PIC32MK General Purpose and Motor Control (GP/MC) Silicon Errata and Data Sheet Clarification

The PIC32MK General Purpose and Motor Control (GP/MC) family of devices that you have received conform functionally to the current Device Data Sheet (DS60001402G), except for the anomalies described in this document.

FIGURE 1: POSC CRYSTAL CIRCUIT

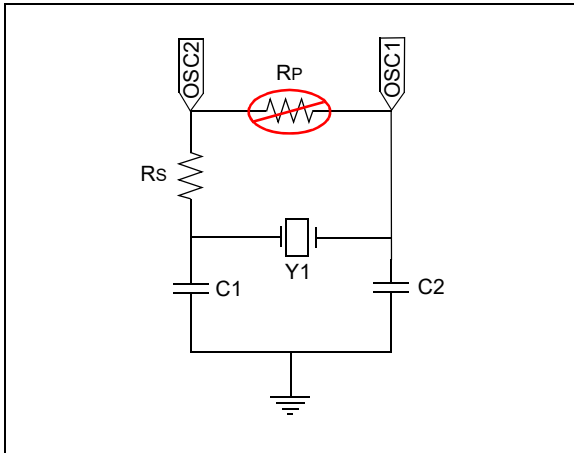
The POSC supports only specific crystal operation, as provided in [Table 1](#).

The Primary Oscillator (POSC) has been characterized to operate at 8 MHz and 12 MHz when the circuit shown in [Figure 1](#) is implemented and the operating conditions provided in [Table 1](#) are met.

- Note 1:** Using any other crystal frequency will require special component selection and characterization.
- 2:** A parallel resistor (Rp) should not be used to increase the gain of the POSC.
- 3:** Only 24 MHz crystals with a Mfg ESR ≤ 40Ω.

FIGURE 2: RESET SUPERVISOR CIRCUIT

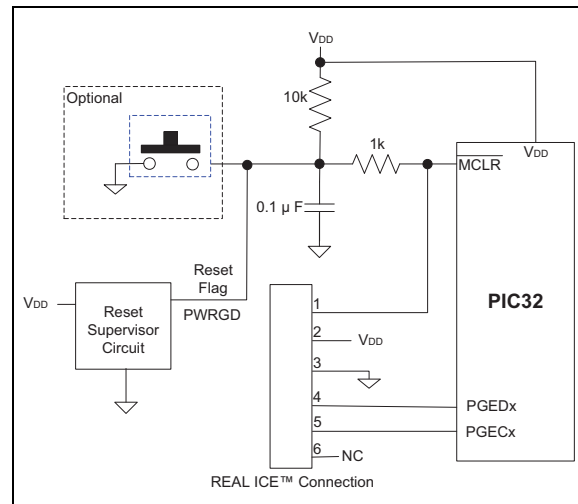
On a BOR event, $V_{POR} < V_{DD} < V_{BOR}$, a Reset is not generated when the BOR threshold is reached. System clocks will stop with all I/O pins functions frozen in their present state until either V_{DD} falls to V_{POR} or V_{DD} returns to above V_{BOR} . The user must assess if this V_{DD} brown-out condition and the resulting frozen I/O pin state has an adverse effect on their application (UART, PWM, I/O, OC, etc.).

Use an external Reset supervisor/monitor (see Figure 2). Some LDO regulators, as listed in Table 4, have an embedded reset supervisor included. The required minimum reset trip voltage of the supervisor should be at least $(V_{BOR} + 0.5V)$ with the SMCLR bit (DEVCFG0<15>) = 0 and the BORSEL bit (DEVCFG2<29>) = 1 in the Configuration Words. This means that the minimum V_{DD} operating voltage of the application needs to be above the reset supervisor maximum trip voltage at [Reset Trip (max) + 0.2V], (i.e. Application $V_{DD(MIN)} = \sim(V_{BOR} + 0.5V + 0.2V)$). The reset supervisor should have an open drain output so as not to interfere with the MPLAB

programming/debug tools. This workaround assures that MCLR will generate an internal POR and reset the I/O pins before the V_{BOR} trip point.
